**RESPONSE TO REQUEST FOR ADDITIONAL INFORMATION ON THE
DRAFT SECTION 3116 DETERMINATION
IDAHO NUCLEAR TECHNOLOGY AND ENGINEERING CENTER
TANK FARM FACILITY**

March 16, 2006

CH2M♦WG Idaho
Idaho Falls, Idaho 83403

Figure RAI-5-1. Graph indicating the point at which tank cleaning is to be stopped.

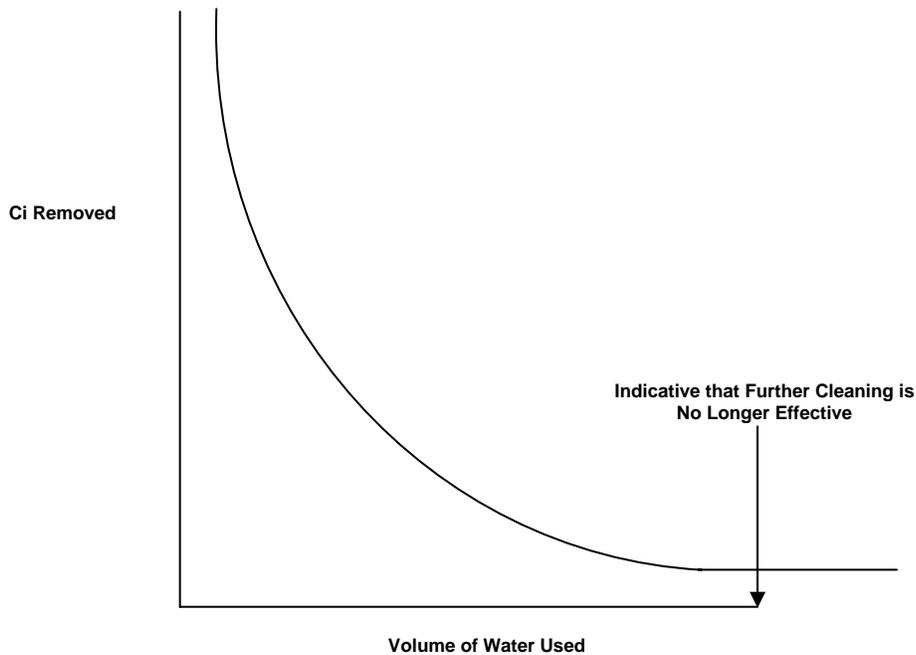
An exponential decrease in concentration in the waste stream has been used to demonstrate that Criterion 2 of the NDAA has been met; however, achievement of an asymptote in the effluent concentration doesn't necessarily show that continued cleaning activities would be ineffectual. The waste determination states the following:

"When radiation levels decrease to the lowest value and remains [sic] constant, cleaning is stopped and the tanks are inspected. If visual inspection via a remote-controlled camera confirms that the tank has been cleaned to the extent practical [sic], then samples are collected and analyzed to verify performance objectives are met." (DOE-ID 2005, page 25)

Cameras installed on the spray cleaning equipment allowed real-time visual examination of the tank internals. Tank cleaning was to continue until (1) radiation levels decreased to the lowest value and remained constant, which would be indicative that further flushing of the tank internals provided no further waste removal (see Figure RAI-5-1), and (2) comprehensive remote visual examinations of the tank internals after each day’s cleaning showed that the spray washing was no longer removing further waste residuals.

Figure RAI-5-3. Cooling coil support plate locations.

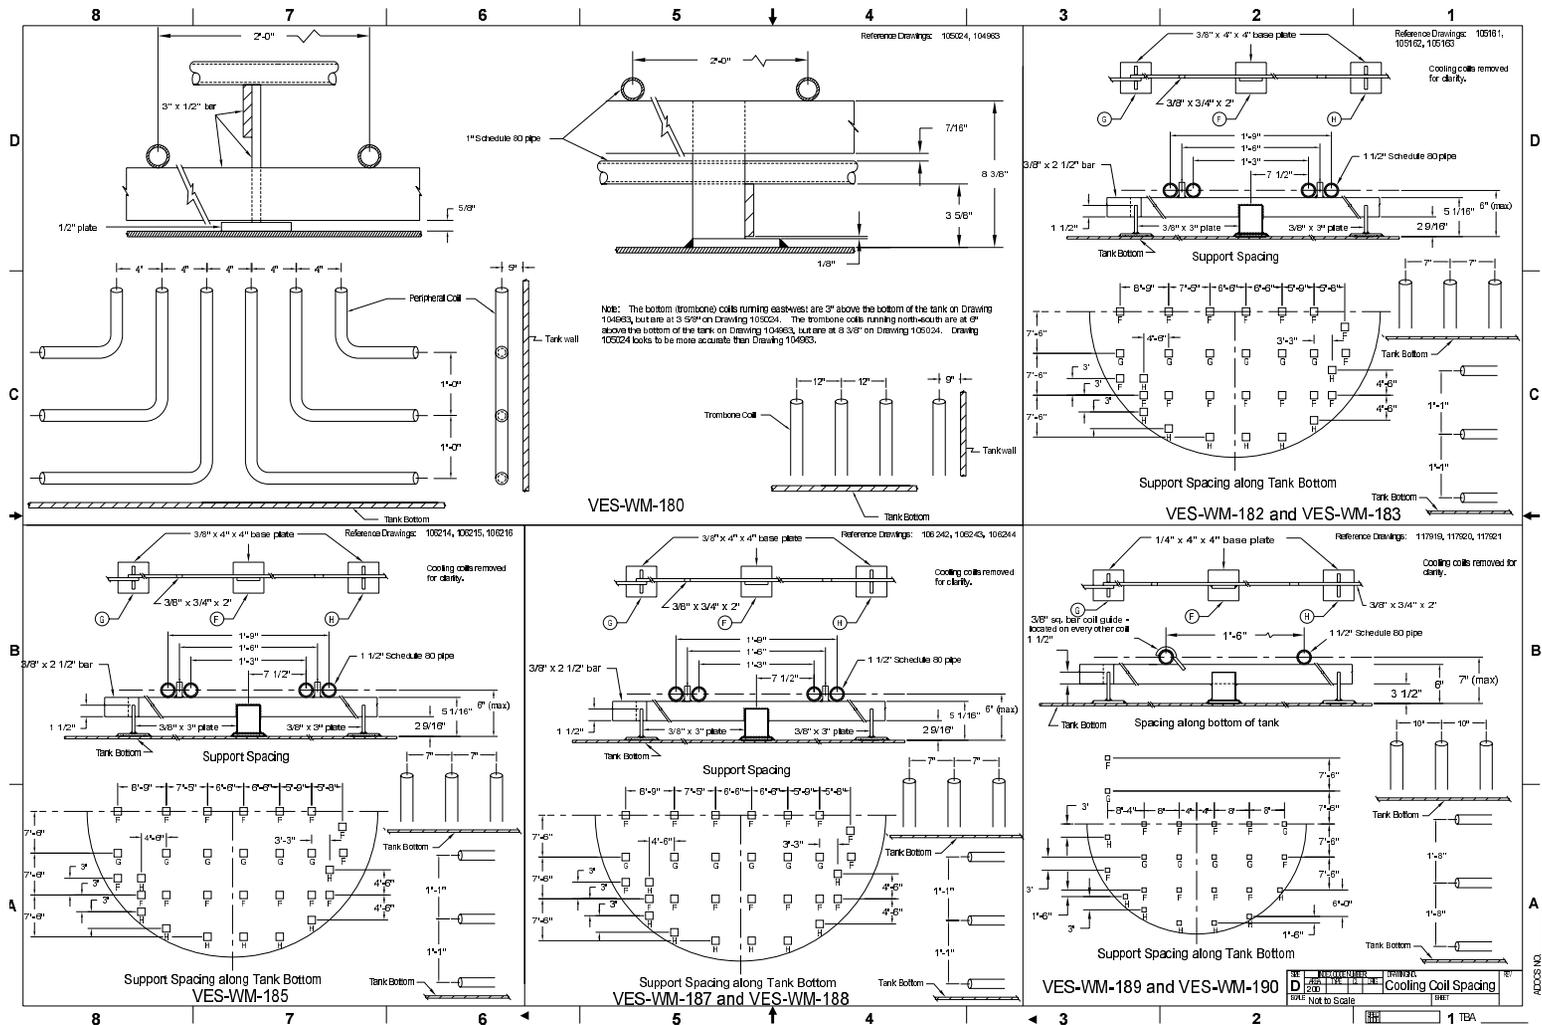
Review of the kriged surfaces in the EDFs for each tank (Portage, 2005a; Portage, 2005b; Portage, 2005c; Portage, 2005d; Portage, 2005e; Portage, 2005f; Portage, 2005g), reveals various patterns of residual contamination in cleaned tanks. The surface for WM-182 was mistakenly included in the EDF for WM-181 (Portage, 2005b). Tanks that did not contain cooling coils appear to have less residual contamination. Some tanks appear to have a ring around the outside of the tank (e.g. WM-185), while most tanks have certain areas where cleaning appears to be less effective. Please comment on the difficulty or inability to slurry remaining solids materials to jet and airlift pumps in tanks such as WM-182, which contains significantly higher residual radioactivity than other cleaned tanks.

Figure RAI-5-3 provides the cooling coil support spacing for the tanks containing cooling coils. The cooling coil support base plates were used as control points in the kriging analyses. Based on video inspection of the tanks, additional control points were established between base plates where no solids were noted and input into the kriging analyses. Based on video inspection, areas in the video that indicated presence of solids materials were outlined with control points between the cooling coils. The number of control points was based on the video observation and the degree to which solids materials were dispersed between cooling coils. If the solids materials were visually consistent in depth between several cooling coil base plate locations, then fewer control points were needed in the kriging analyses.

During this kriging analysis of the tank bottoms to estimate residual solids, every effort was made to provide a reasonably accurate, yet conservative estimate of the depth of remaining solids. The video and kriging analysis of the tank residual solids materials has inherent uncertainties. These uncertainties are due to the difficulty in estimating the fraction of the solids depth near the cooling coil support base welds and estimating the interface of solids materials between welds, especially in areas where the solids are thinning to a zero thickness. However, the uncertainty in the depth of residual solids materials was controlled by using conservative estimates of the depth of solids materials. For example, solids materials near the cooling coil base plates were assigned a depth of 3/8 in. when the solids materials were near the surface of the base plate, and the base plate was still visible. In cases where the base plate was slightly visible, the depth of solids materials were assigned a depth of 0.5 in. The control points for areas that had a reflective bottom surface were feathered at a fairly steep rate toward the areas containing solids materials. This slope of material is assumed to be much more gradual in a water deposition environment. In all cases, only areas that could be clearly defined as containing minimal solids residuals were assigned values less than the maximum from the nearest control point. The uncertainty in the solids estimate is also mitigated by the methodology that was used to estimate mass of the solids. The supernate, or interstitial liquids in solids, was not introduced in the calculation of solid mass. Analysis of the pre-wash samples showed that 25% of the heel solids were actual solids and the remaining 75% were interstitial liquids (EDF-TST-001, 2000). Therefore, by assuming the entire depth of solids from the kriging analysis is all solids and not discounting that much of the volume is interstitial liquid, a conservative estimate is developed.

Figure RAI-6-1. Grout pour lift sequences and dimensions.

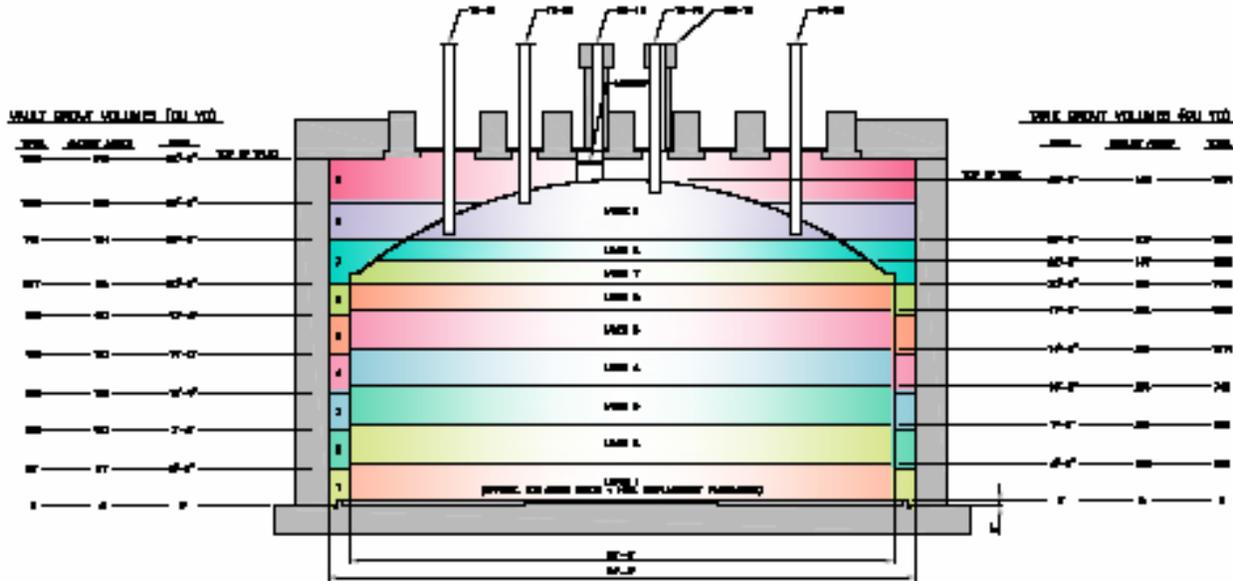
Provide a technical basis for the anticipated thermal and mechanical history of the various cementitious materials. Provide any available data on the isothermal shrinkage of the two main material types (concrete and grout) and assess the additional impact of the thermal excursion arising in the course of emplacing the grout and its subsequent hardening. Explain how the dimensional changes would translate to the incidence of voids and cracking and the five stages illustrated in DOE-ID (2003b, Figure E-1).

grout behavior (EDF-6715, 2006). The grout is scheduled to be poured in a series of nine separate layers, each with a thickness of approximately 1 m (see Figure RAI-6-1). Since the volume of grout contacting the vault during each pour will be relatively small, there will not be any significant thermal or mechanical stresses to the vault walls. Time between pours will allow for cooling. Procedures will be in place during grout pouring to protect the integrity of the tank and vault during grout pours by limiting temperature rise and volume change.

Figure E-1. Conceptualization of the representative TFF tank, grout, vault, and piping system shown in (a) and the degradation sequence (b) through (e) at the TFF.^b

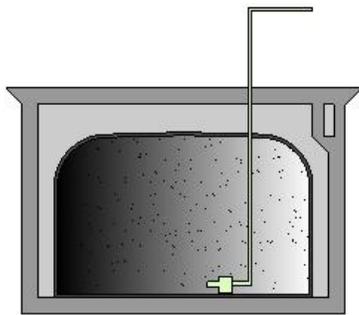
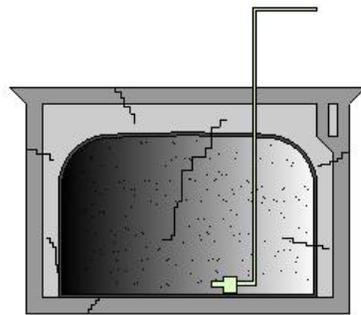
The conceptualized model showing the evolution of the vault [DOE-ID, 2003b, Figure E-1(a) and associated text depicts the outer concrete vault as uncracked in the initial phase, but shows the presence of "shrinkage cracks" on the vault and grout after the grout pour [DOE-ID, 2003b, Figure E-1(b)]. Information would be helpful regarding how the conceptual model accounts for the formation of voids and cracks due to the thermal regime resulting from the heat of hydration of the grout pour and due to the physical coupling between concrete and grout.

Explain how the dimensional changes would translate to the incidence of voids and cracking and the five stages illustrated in DOE-ID (2003b, Figure E-1).

Figure E-1 (attached) is a artistic conceptual drawing showing the evolution of system degradation in a general sense. The stages of degradation in terms of the numbering in the figure from (a) to (e) are as follows:

- a) Initial condition after grout pours are finished: Cracks are present in the grout between the tank and the vault, and inside the tank. Grout pour does not crack the vault. The vault system is buried beneath the land surface, such that structural support is provided by the soils surrounding the vault. Therefore, cracking of the vault during the grout pour is not expected.
- b) Steel reinforcement in the outer vault corrodes. Volume expansion from corrosion causes spalling around corroded reinforcement.
- c) Degradation front passes through the vault and reaches the outside of the stainless steel tank.
- d) The stainless steel tank may take more than 20,000 years to fully corrode, but is assumed to have initial localized penetrations.
- e) Entire system converts to rubble.

Figure RAI-9-1. Probable maximum flood Idaho National Engineering and Environmental Laboratory (INEEL) (now INL) inundation map.

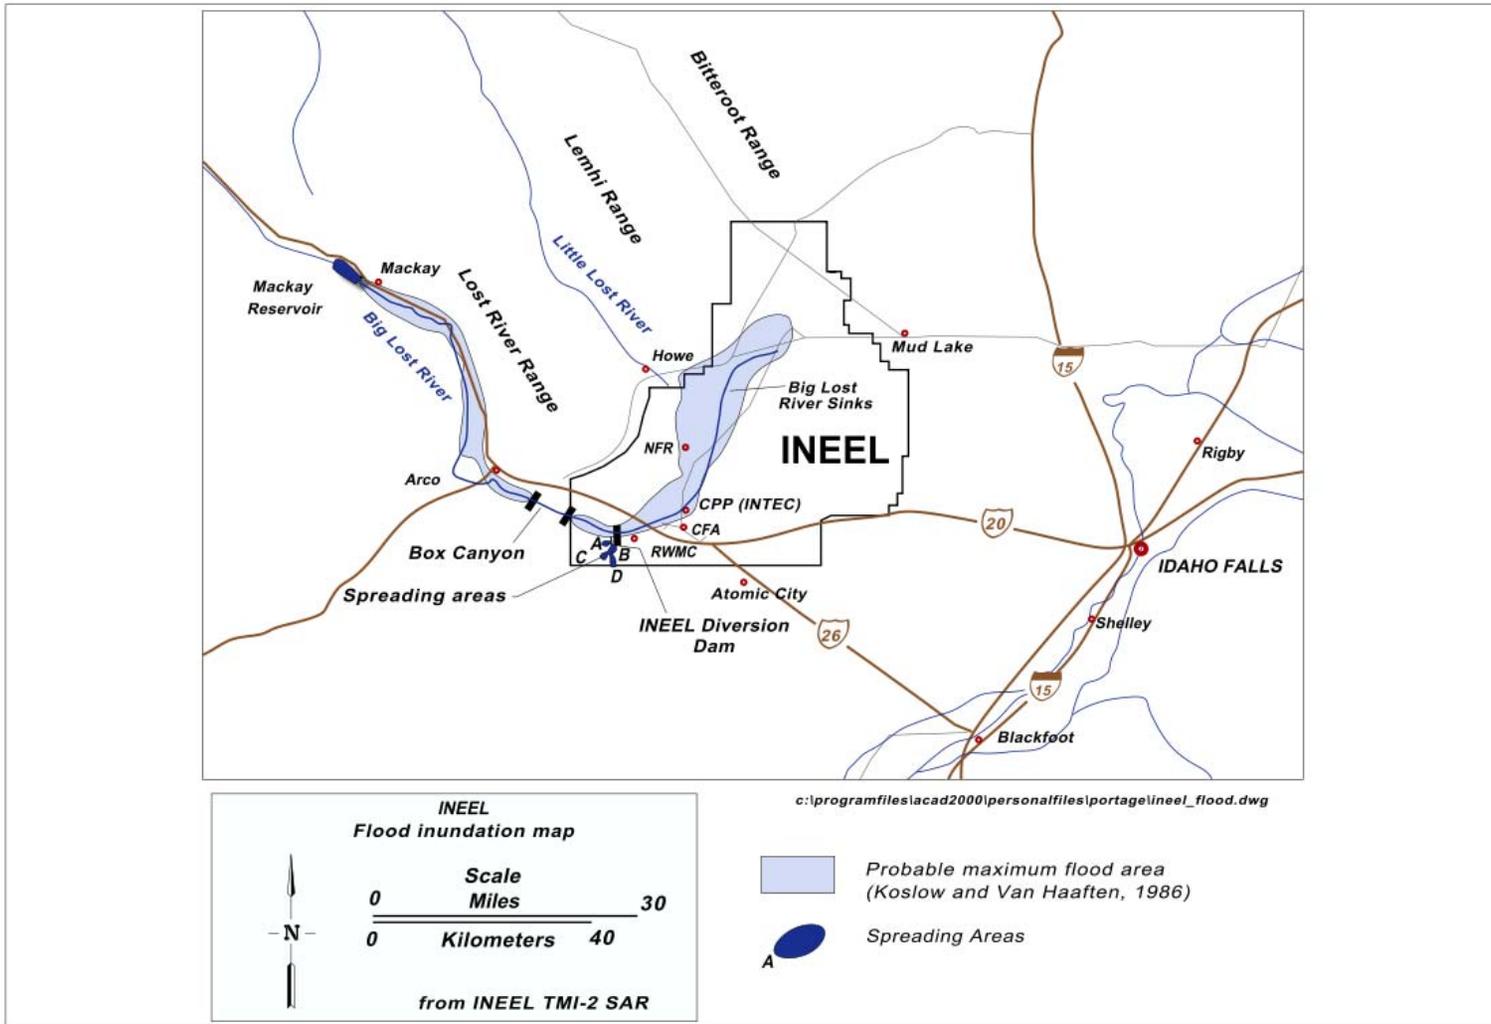
Figure 2-18 shows the areal coverage of a Probable Maximum Flood at INL (DOE-ID, 2003b). It is difficult to review Figure 2-18 because its resolution is low. The figure would be more useful if shown at a higher resolution. The location of Idaho Nuclear Technology and Engineering Center is not superimposed on the inundation map shown in Figure 2-18, yet its location apparently near a margin of the flooded area is supposed to support the flooding analysis.

DOE-ID should provide a higher resolution figure of the relevant portions of Figure 2-18. DOE-ID should also show the location of INTEC superimposed on the higher-resolution inundation map.

A higher resolution figure of the relevant portions of Figure 2-18 from the PA (DOE-ID 2003) is included as Figure RAI-9-1, with the location of the Idaho Nuclear Technology and Engineering Center (INTEC) (formerly CPP) superimposed. Figure RAI-9-2 is a topographic map of the TFF. The ground elevation around the tanks varies between 4,914 and 4,916 ft (amsl). The estimated flood elevation is 4,917 ft, providing between 1 and 3 ft of flood water inundation over the tanks.

Figure RAI-9-2. Topographic map of the Tank Farm Facility (flood depth is 4,917 ft in elevation).

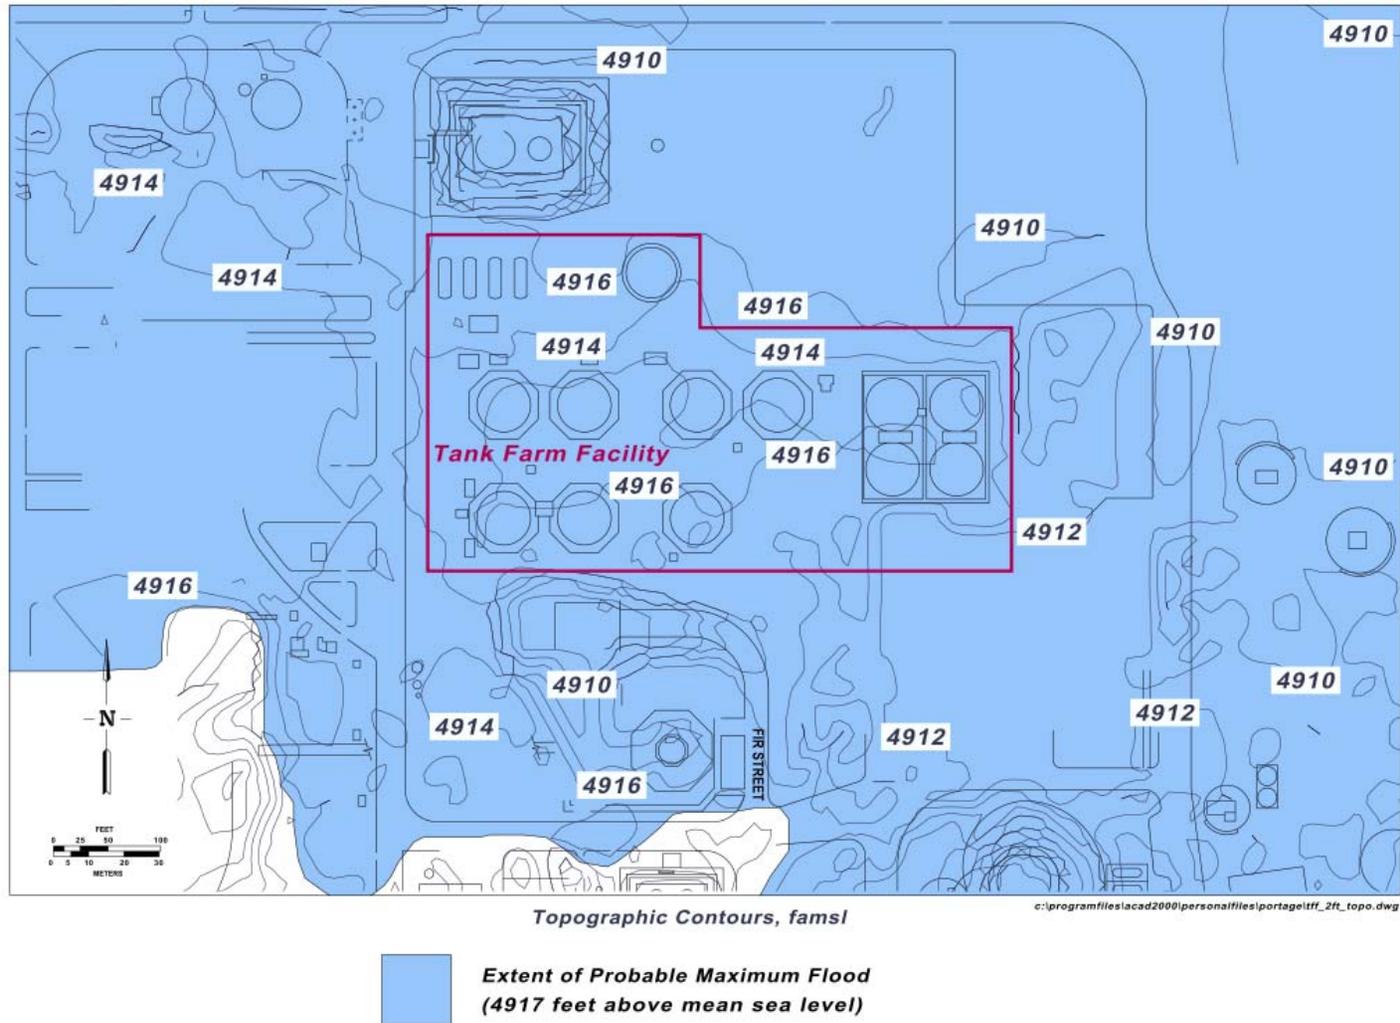
DOE-ID should provide a higher resolution figure of the relevant portions of Figure 2-18. DOE-ID should also show the location of INTEC superimposed on the higher-resolution inundation map.

Figure 7-15. Comparison of radionuclide concentrations at the water table for non-flooding and flooding conditions.^c

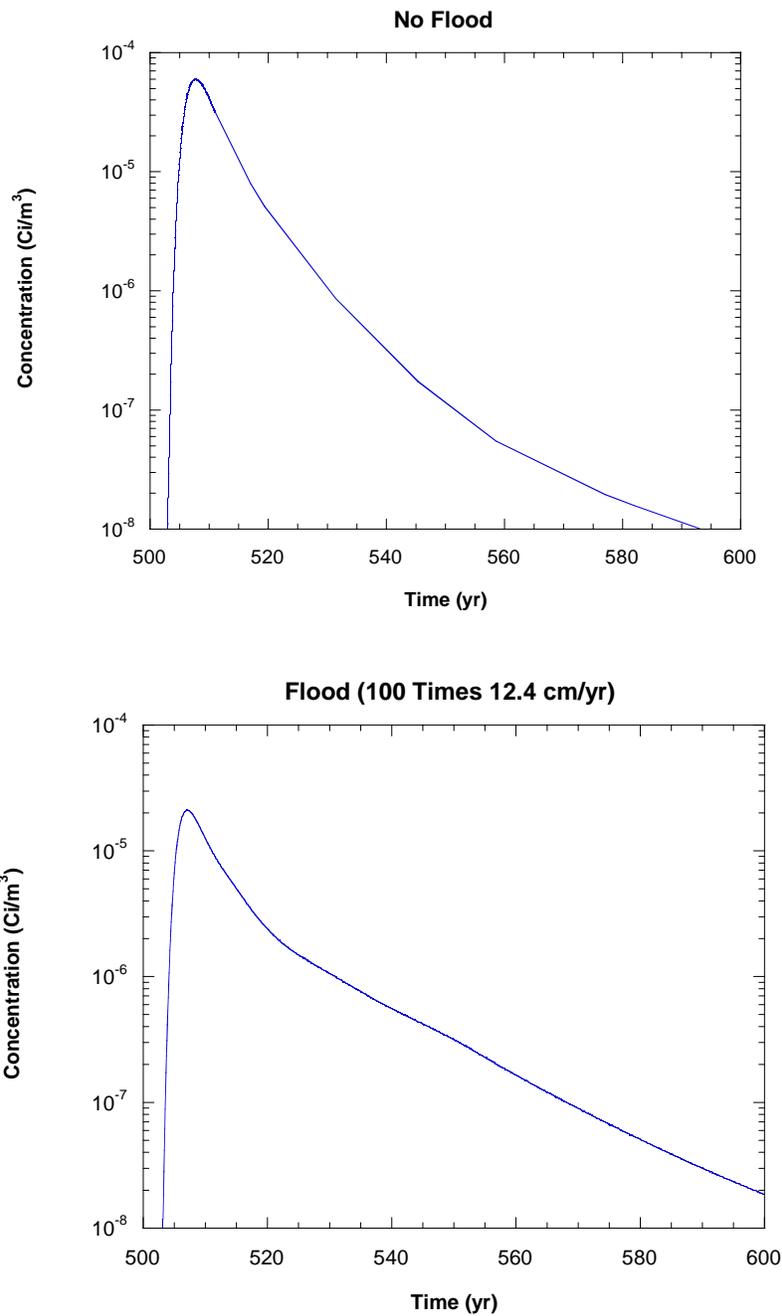
The NRC notes that PA Section 2.1.5.3.6 states “The flood hydrograph for the base-case discharge shows a peak flow that lasts only 7.5 hours (Figure 2-19).” The NRC also notes that the PA states “Since the INTEC facility is located at the boundaries of the flood, the area would be inundated for a lesser period of time (p. 2-38).” The NRC states “The information conveyed in the second sentence called out above does not necessarily follow from the information conveyed in the first sentence: The duration of peak discharge does not necessarily imply how long water may pond at the surface of the TFF or elsewhere (see also Section 7.4.2, page 7-26).” The INL agrees with NRC that the statement is in error. The peak flow rate duration is not an indication of how long water may pond at the TFF. The peak flow rate would be expected to be less at the margins of the flood channel.

Peak concentrations at the water table are lower for a flooding scenario compared with steady-state simulations. Larger floods provide more water for recharge and subsequent dilution of contaminants. The PA (see Figure 7-16; attached) shows the impact on perched water zones due to the PMF flooding event. The increase in the number, size, and location of perched water zones will increase the dilutions of the contaminants.
